ALERT SERVICE BULLETIN

429-15-21

MODEL AFFECTED: 429

SUBJECT: 429-001-523-101/-103 AND 429-001-532-101/-103
BELLCRANK ASSEMBLY INSPECTION,
INTRODUCTION OF.

Figure 1 -Bellcrank Assemblies

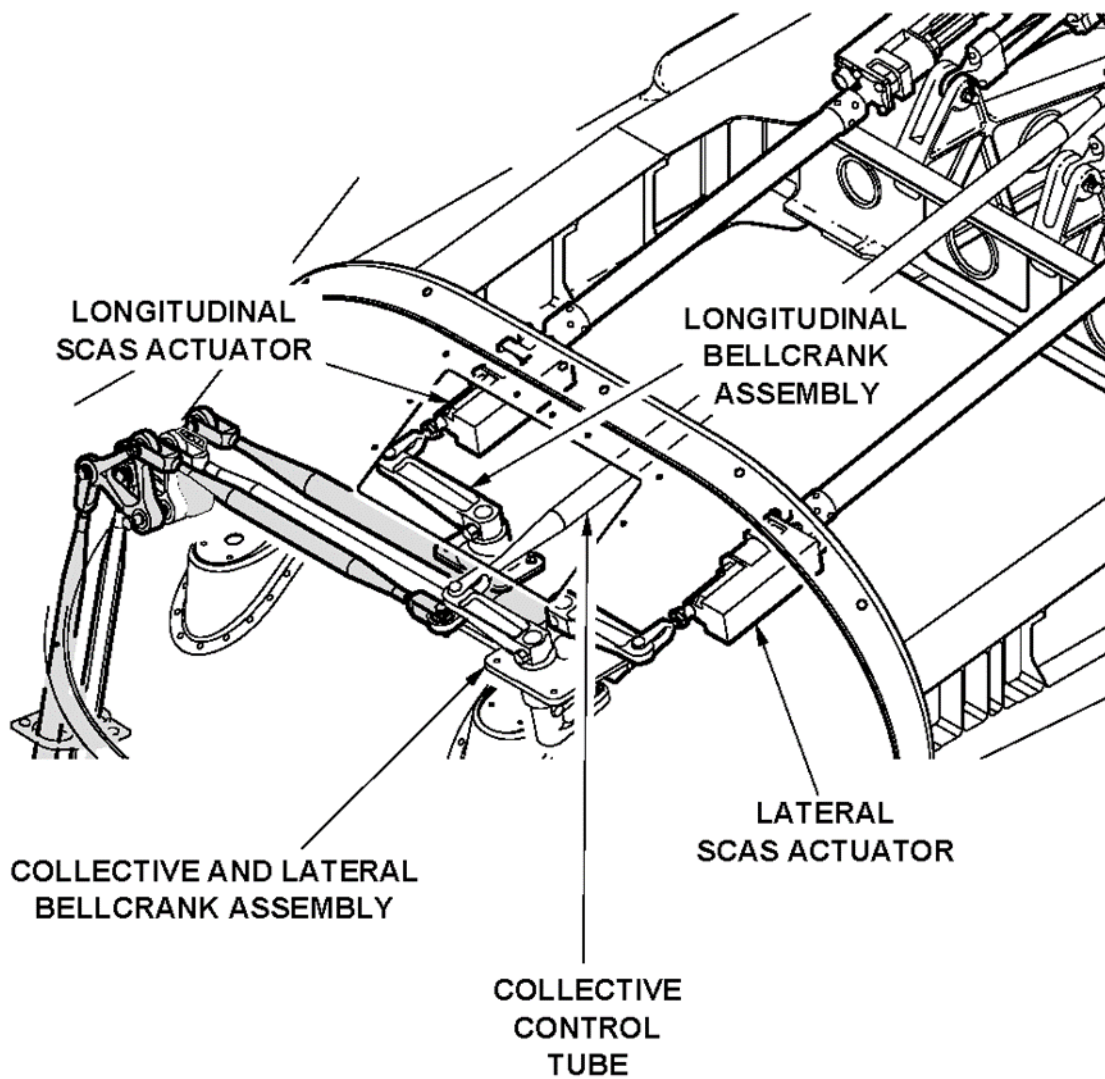
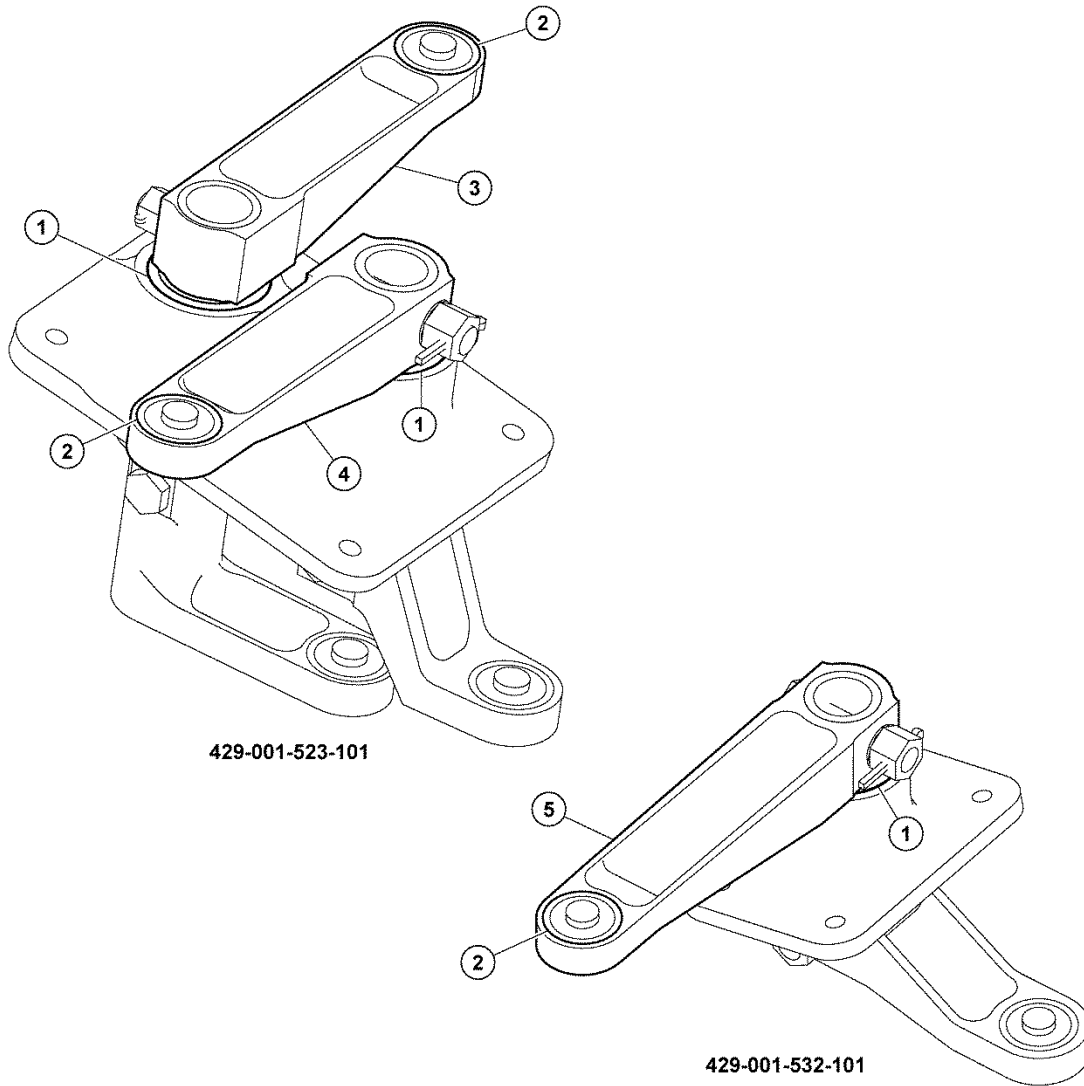
1. Prepare the helicopter for maintenance.
2. Disconnect the forward ends of the collective control tube, longitudinal SCAS actuator, and lateral SCAS actuator (Figure 1) (BHT-429-MM-1, Chapter 67).

3. Slowly move the cyclic stick fore/aft and laterally, and the collective stick up/down from stop to stop. If any roughness is detected in the flight control system, Perform TB 429-18-58.
4. Should discrepant pivot bearings be found that require replacement, contact Product Support Engineering to report findings.
5. Check that the MS27643-4 bearings (Item 2) in the 429-001-525-101 collective (Item 3), 429-001-527-101 lateral (Item 4), and 429-001-530-101 longitudinal (Item 5) arm assemblies rotate freely. If binding is detected in any MS27643-4 arm end bearings, perform TB 429-18-58.

6. Should discrepant arm bearings be found that require replacement, contact Product Support Engineering to report findings.;
7. Connect the forward ends of the collective control tube, longitudinal SCAS actuator, and lateral SCAS actuator (Figure 1) (BHT-429-MM-1, Chapter 67).
8. Make an entry in the helicopter logbook and historical service records indicating compliance with **Part I** or **Part II** of this Alert Service Bulletin, as applicable.
